Drawing Title
Comparison of west elevation

Job Title
33 West Front Road, Pagham

Job No
2502
Drawing No
SK03
Rev
A

2. Proposal as drawn in granted scheme (1:125)

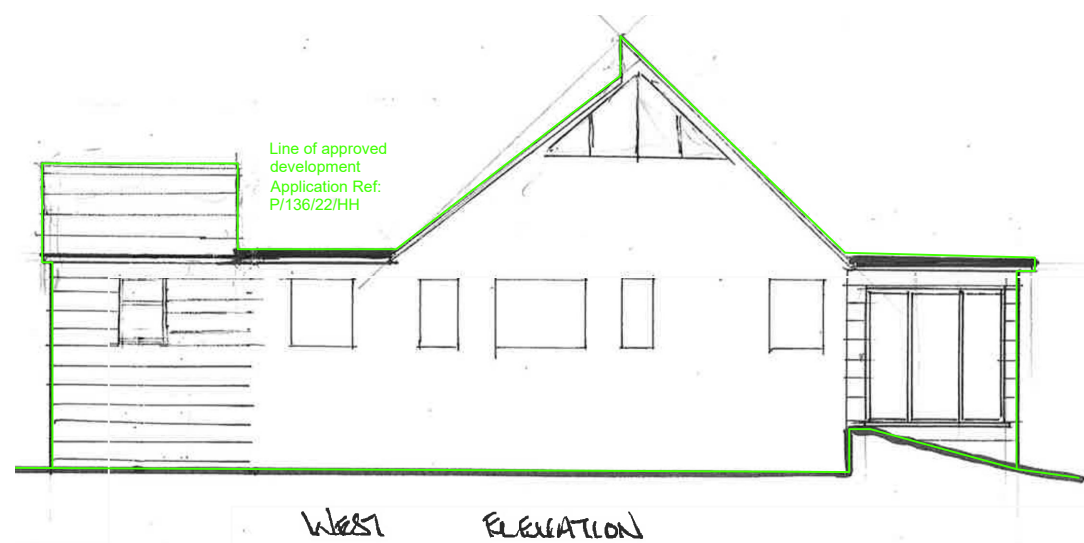
No levels on the proposal. But the granted scheme increases the ridge height and introduces extensions that look bolted in - not coherent or considered.

4. New application to be submitted as Removal/Variation of Condition application (1:125)

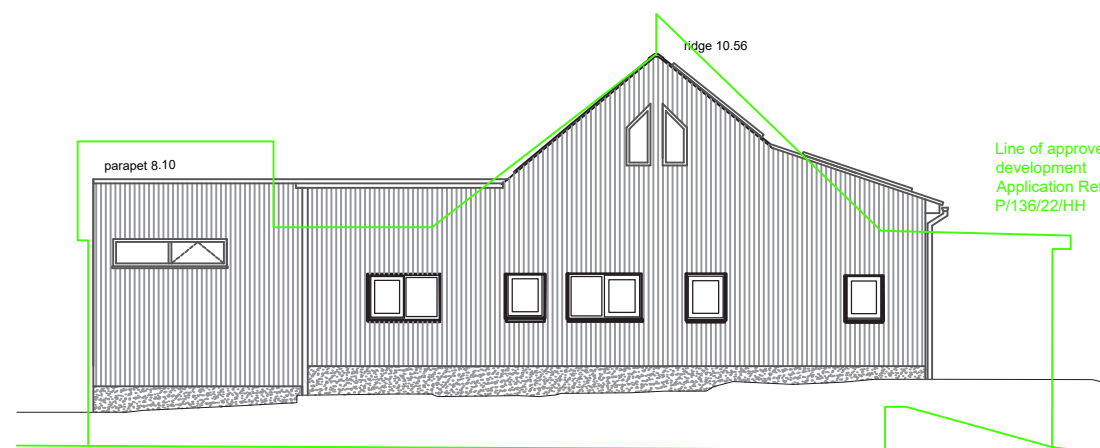
Our proposal retains the existing ridge height and consolidates the overall building mass which respecting what currently exists on the site. Most importantly, allowing the clients to reveal and restore the train carriages internally.

Our proposed elevation also reduces the size of windows and shows the new external cladding and insulation to make the house more thermally efficient.
